**To:** Andrew MacNichol , Community Development Director  
**From:** Ryan A. Percival, P.E., Town Engineer  
**CC:** Mary Benedetto, Senior Planner  
**Date:** July 6, 2023  
**Re:** Grandview Road Extension

**PLAN SET:**  
MAJOR SITE PLAN MODIFICATION  
GRANDVIEW ROAD SUBDIVISION - PRIVATE WAY  
(GRANDVIEW ROAD EXTENSION)

We have reviewed the comments provided by the CPDC and Engineering Division in regards to the the Major Modification of a Definitive Subdivision known as Grandview Road. Comments and associated responses by Fodera Engineering (FE) follows:

JOB NO.: 20160-149  
**SHEET TITLE:**  
DETAILS  
SHEET 1  
**SHEET NUMBER:**  
C-6

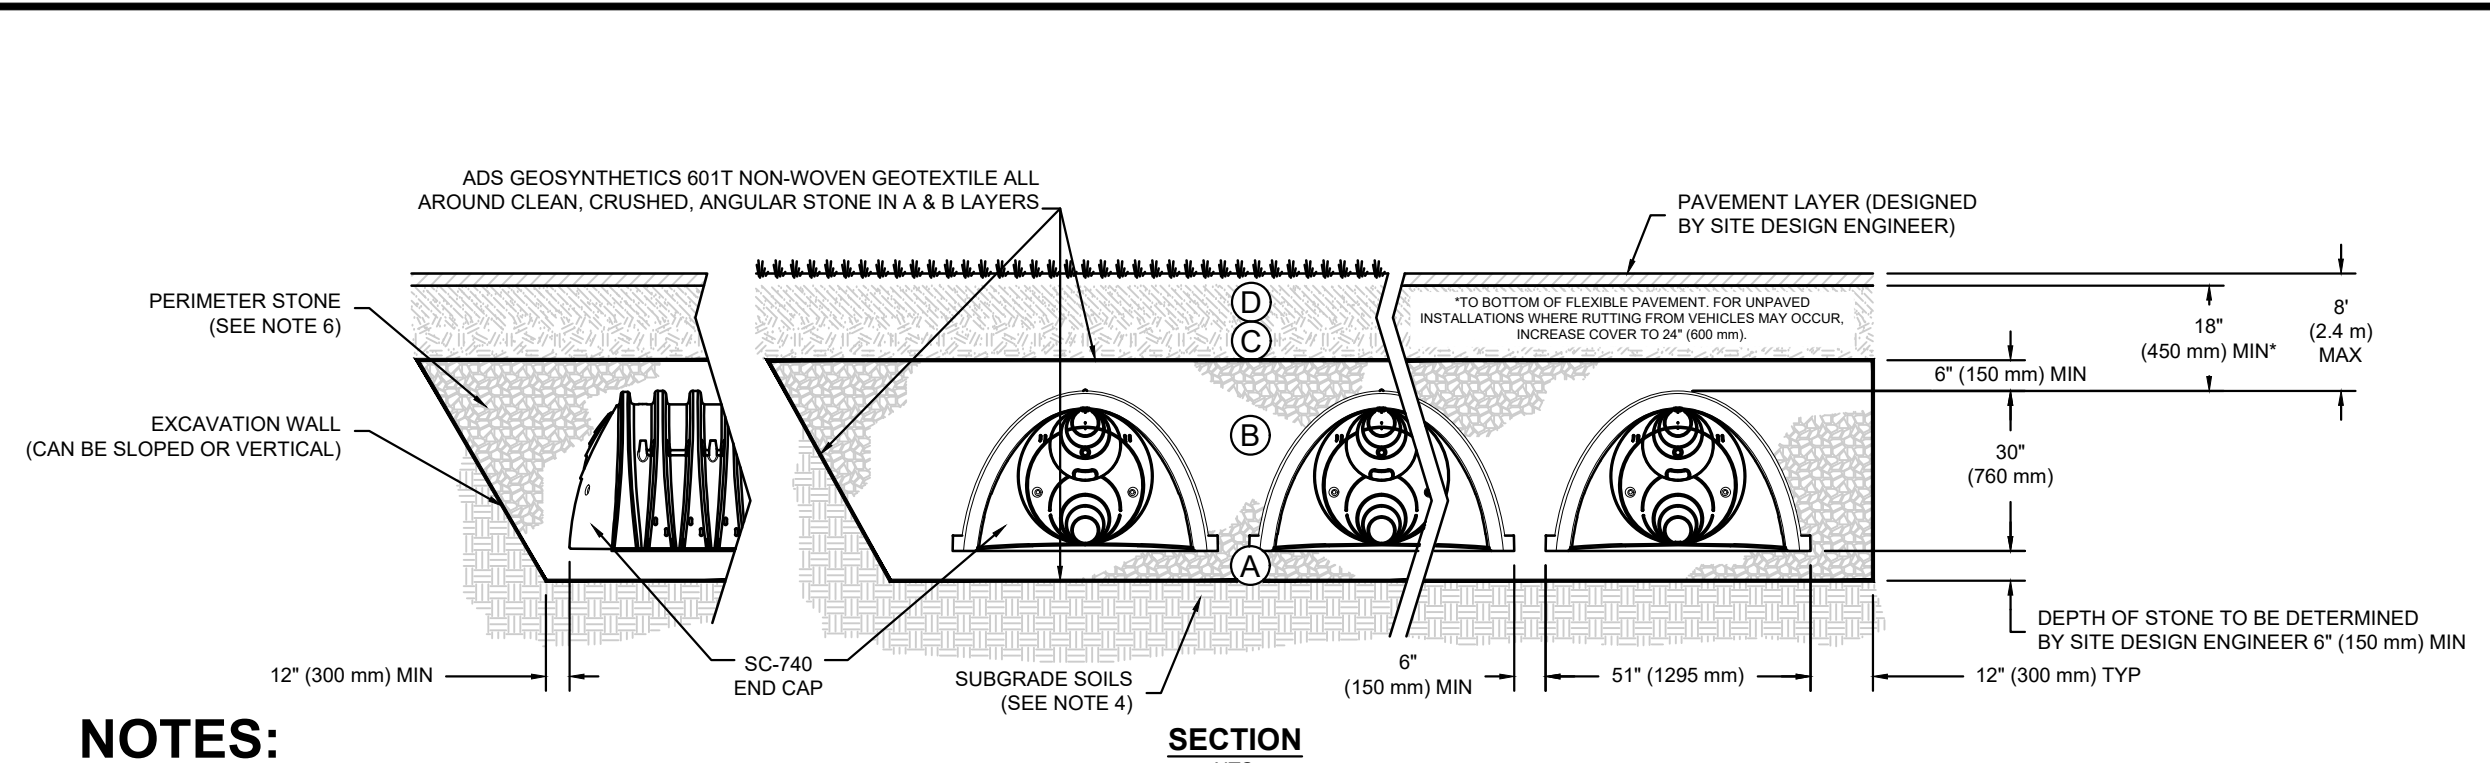
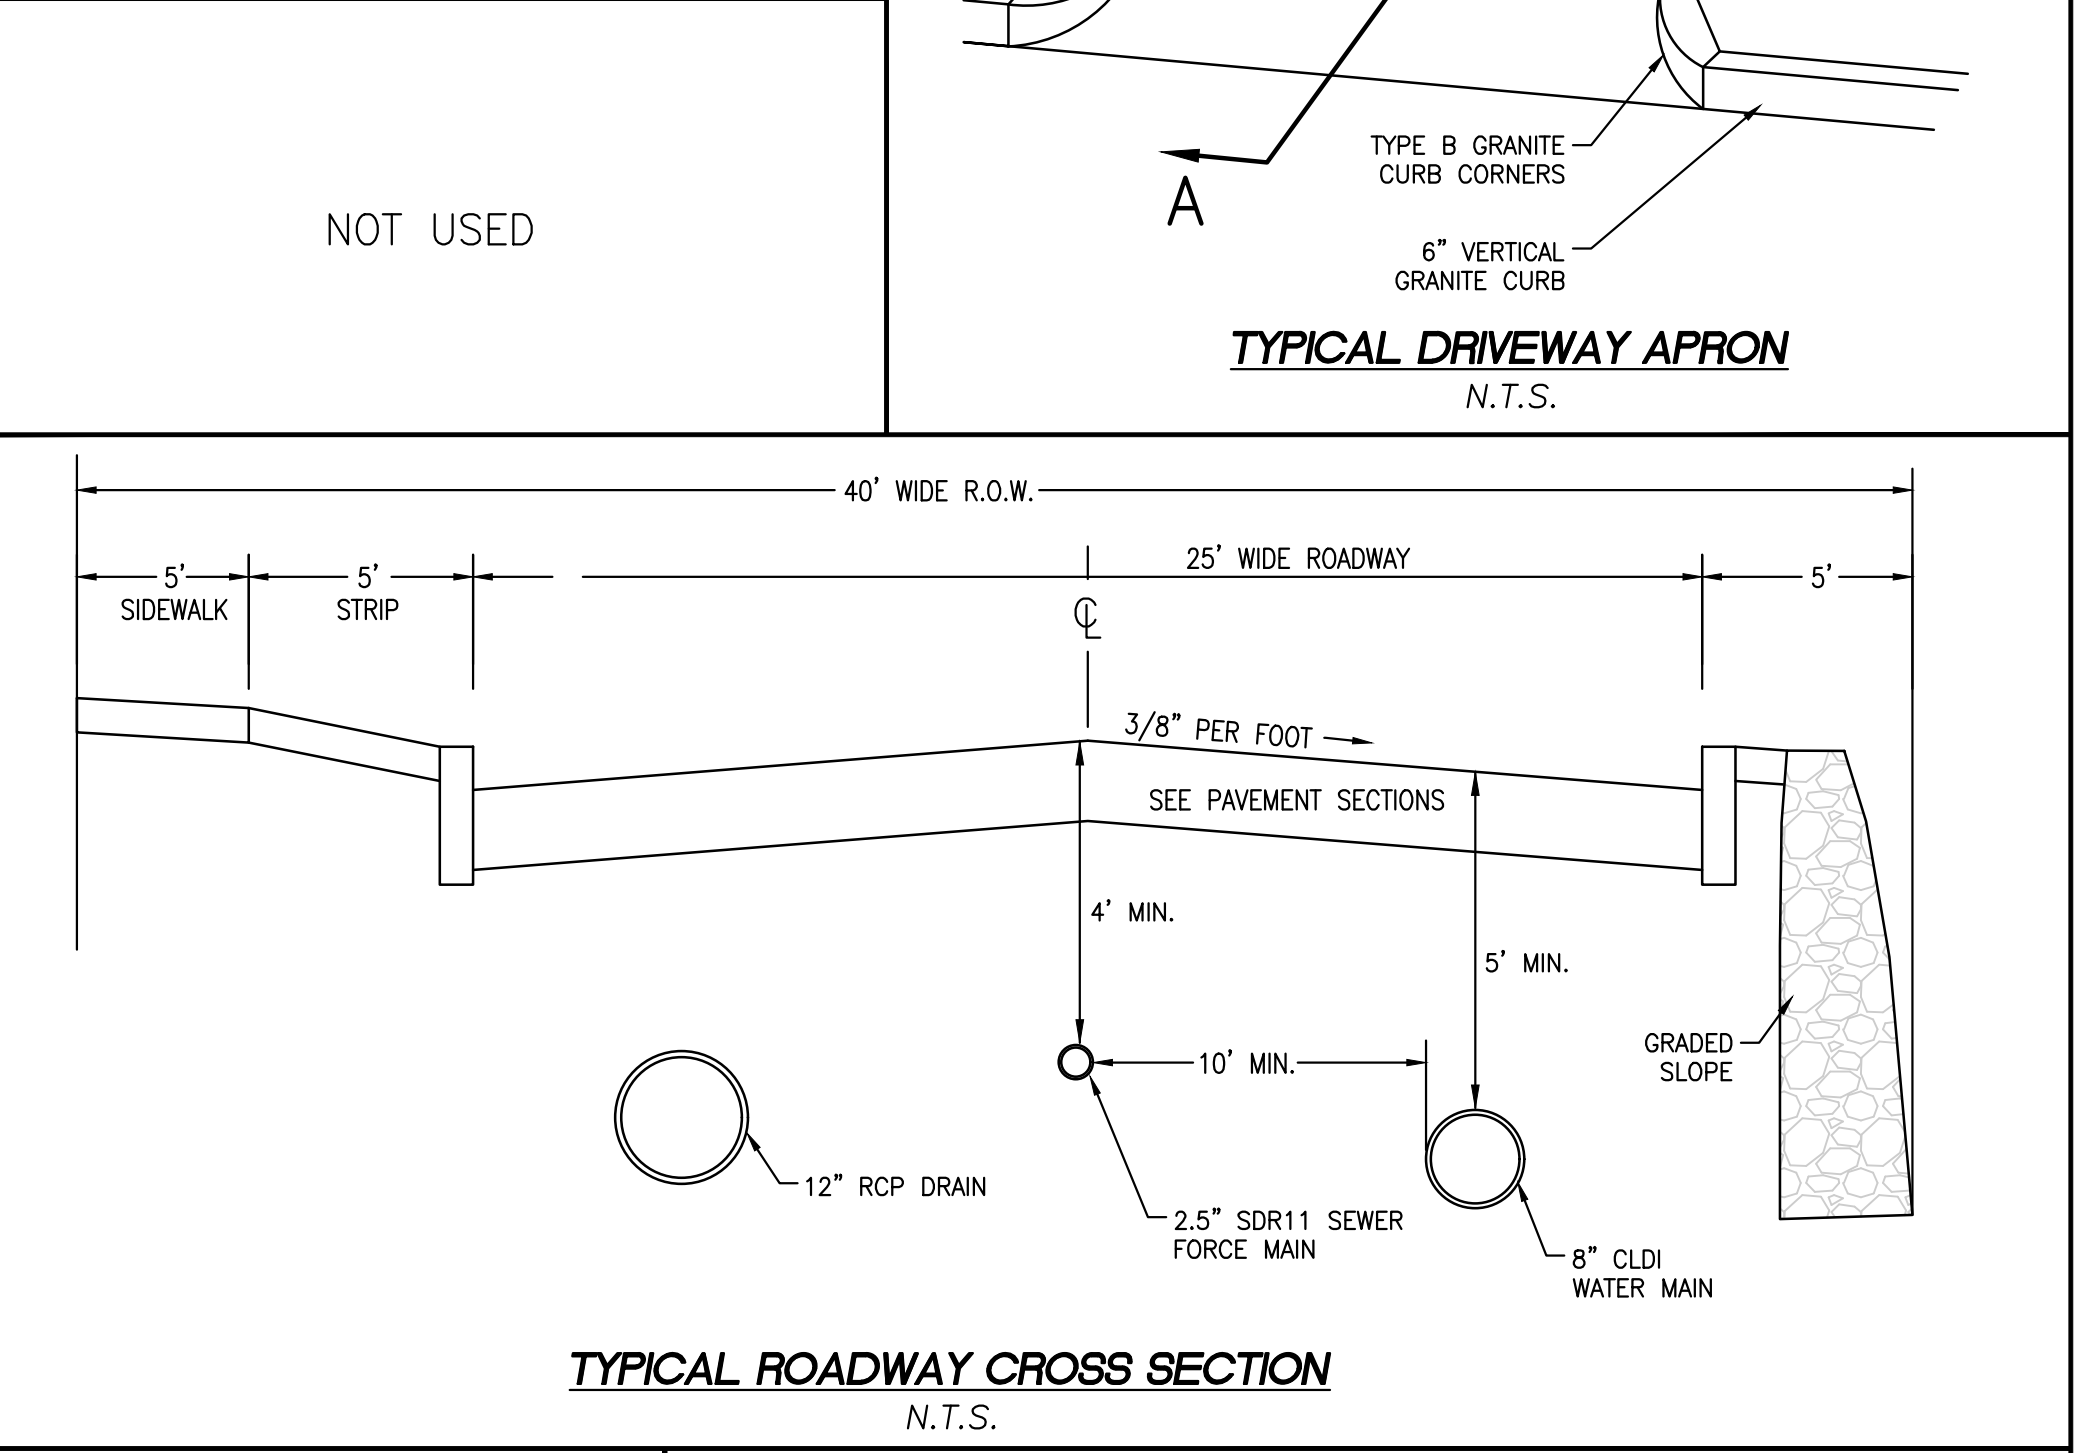
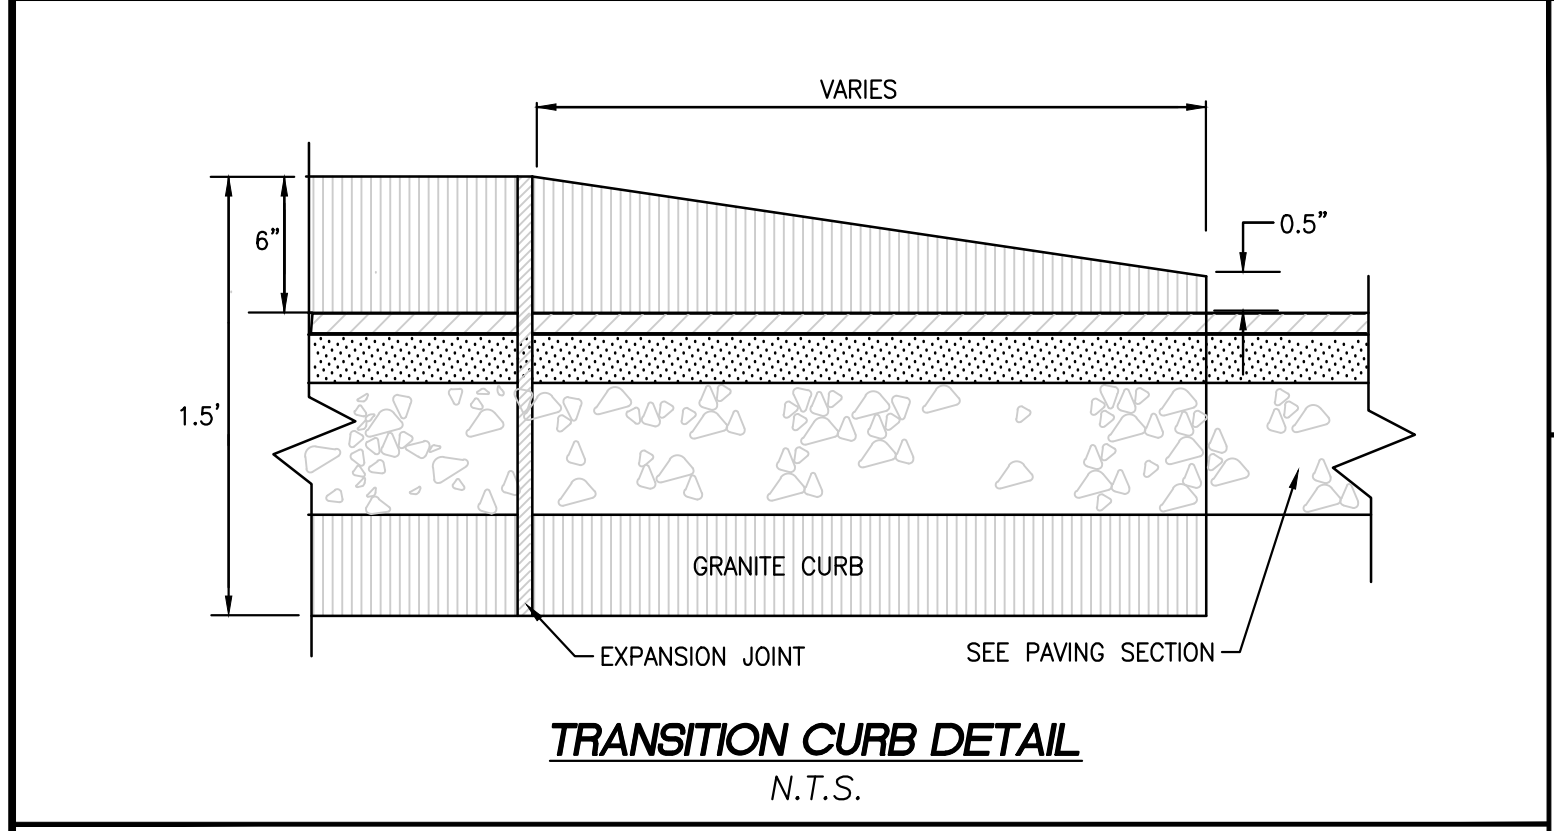
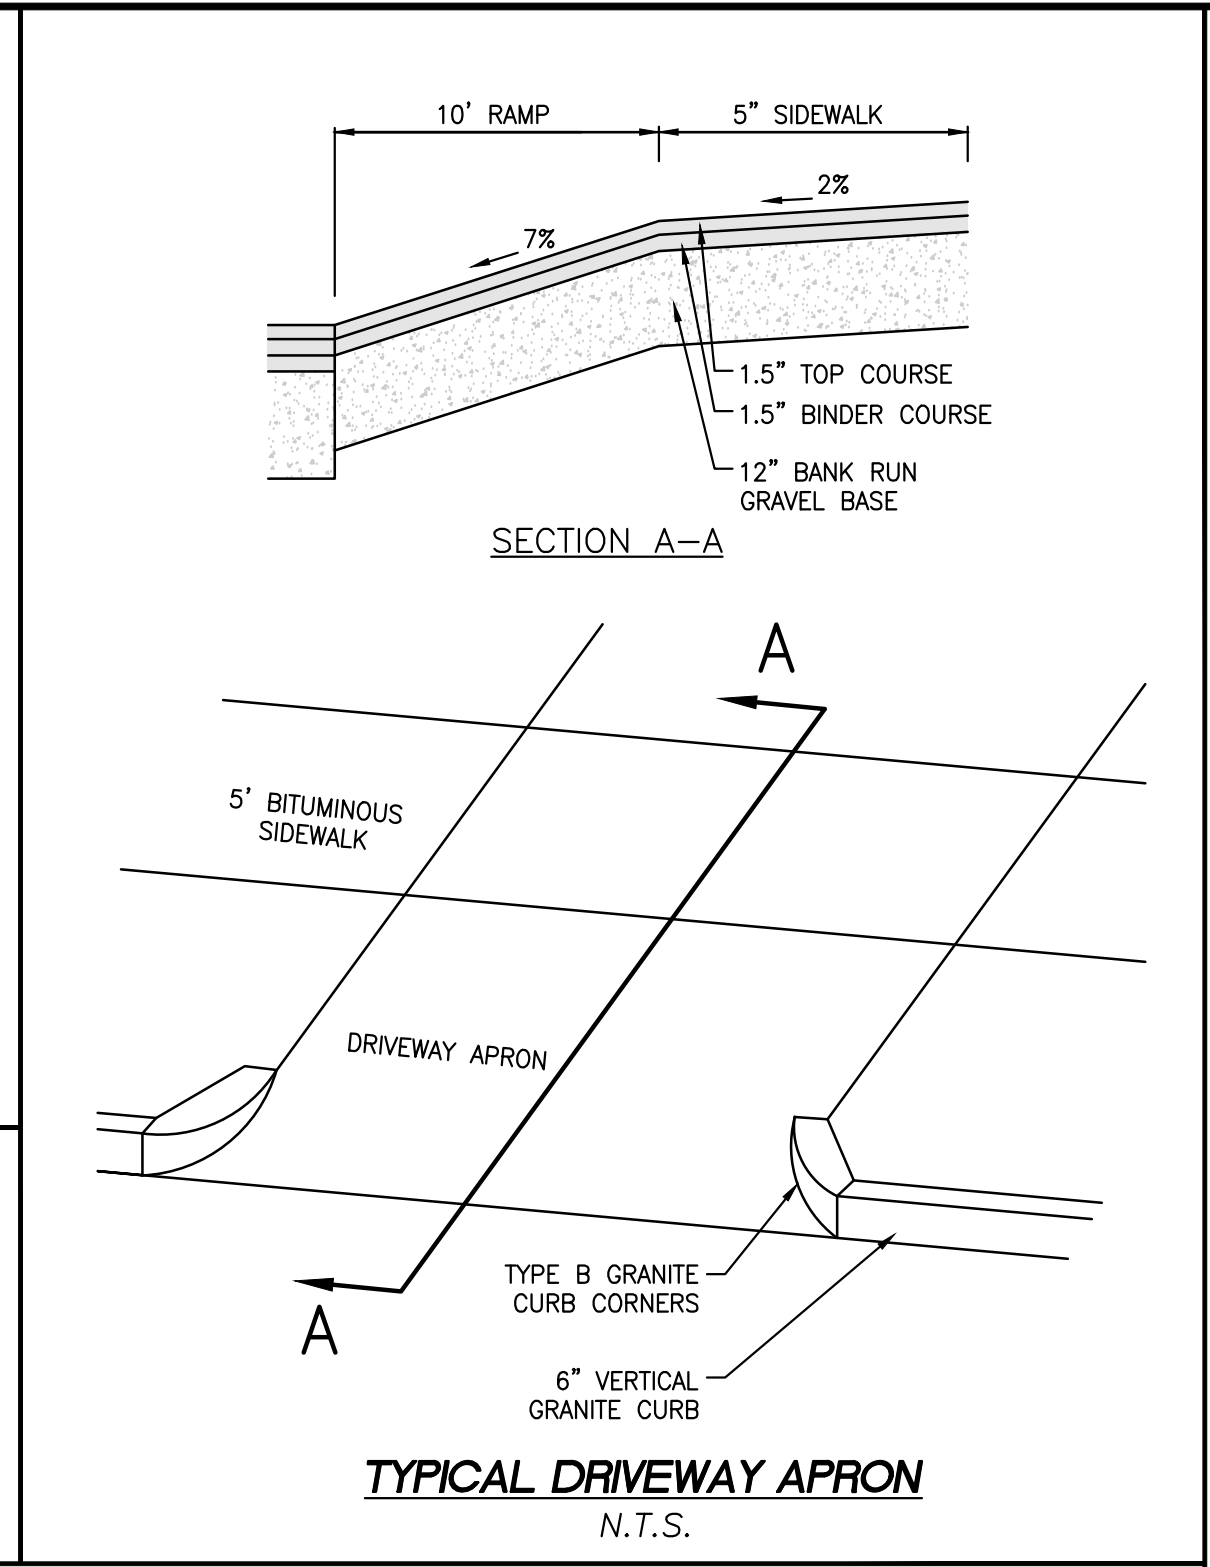
***FE Response: We limited crossings of utilities but it is inevitable that crossings will occur. There is a “Water Main Crossing” detail on sheet C-6.***
